AMENDMENT OF SOLICITATION/MODIFICATION OF CONTRACT				1. CONTRACT ID CODE	PAGE 1 OF 2 PAGES
2. AMENDMENT/MODIFICATION NO. AMENDMENT NO. 0004		3. EFFECTIVE DATE 9/15/11	4. REQUISITION/PURCHASE REQ. NO.	5. PROJECT NO. (If applicable) 11-0117	
6. ISSUED BY CODE		jsy	7. ADMINISTERED BY (If other than Item 6) CODE		See Item 6
Officer in Charge of Construction MCI-East 1005 Michael Road Camp Lejeune, NC 28547-2521					
8. NAME AND ADDRESS OF CONTRACTOR (No., street, county, State and ZIP Code)				(X)	9A. AMENDMENT OF SOLICITATION NO. N40085-11-R-0117
				X	9B. DATED (SEE ITEM 11) 9/9/11
					10A. MODIFICATION OF CONTRACT/ORDER NO.
					10B. DATED (SEE ITEM 11)
CODE		FACILITY CODE

11-0117, Repair Applied Instruction Building, BB-50

AWNING DETAIL BLDG BB 50
APPLIED INSTR. BLDG. BB 50
MCB CL COURTHOUSE BAY

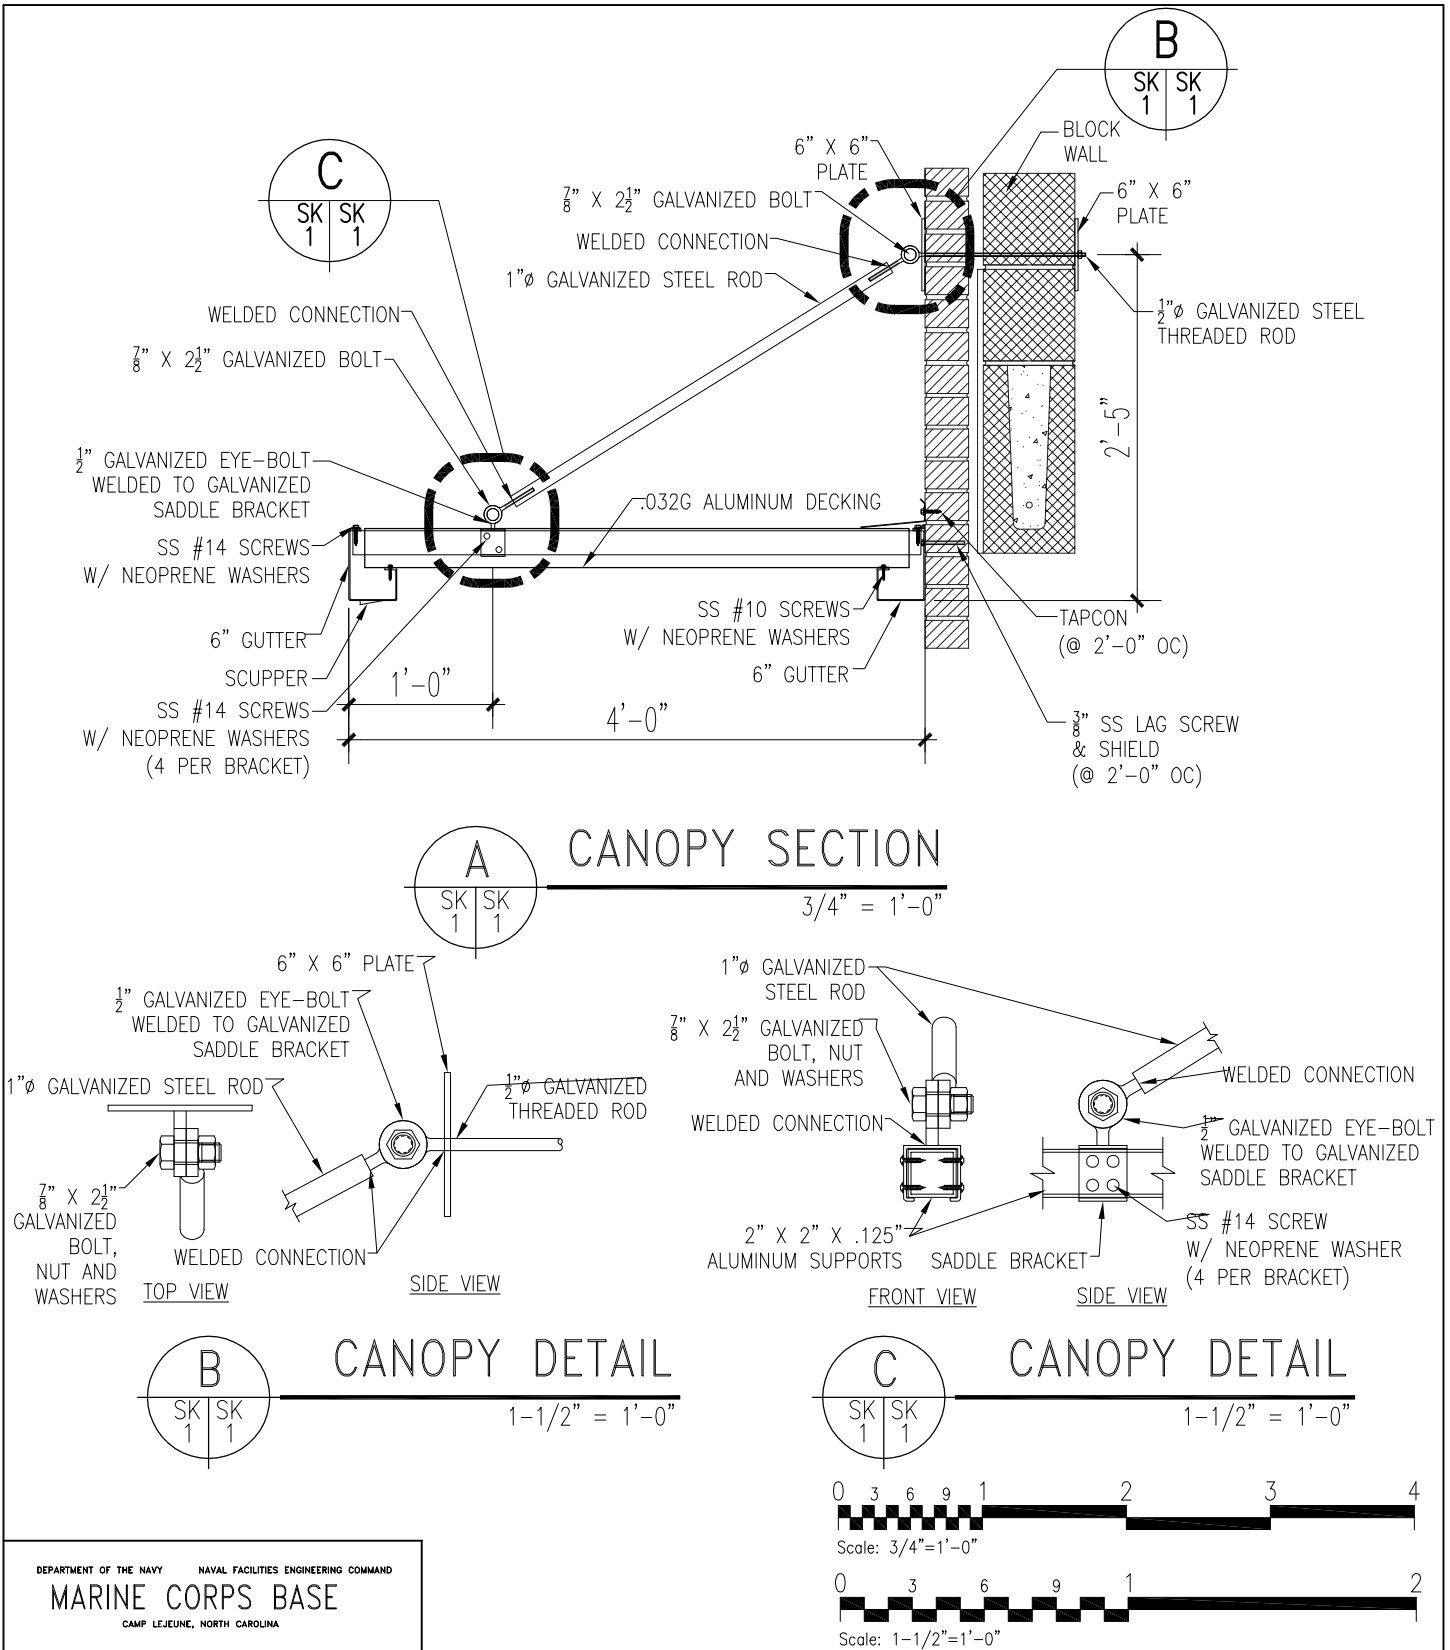
Q: Drawing A4, note 4 says Install New Metal Awning above Exterior Doors. Specifications or details were not provided for the Awning/Canopy. Will they be issued by Amendment? Please advise.

A: The new metal awnings/canopies shall be per the attached detail. Install two supports per awning (one on each side of awning).
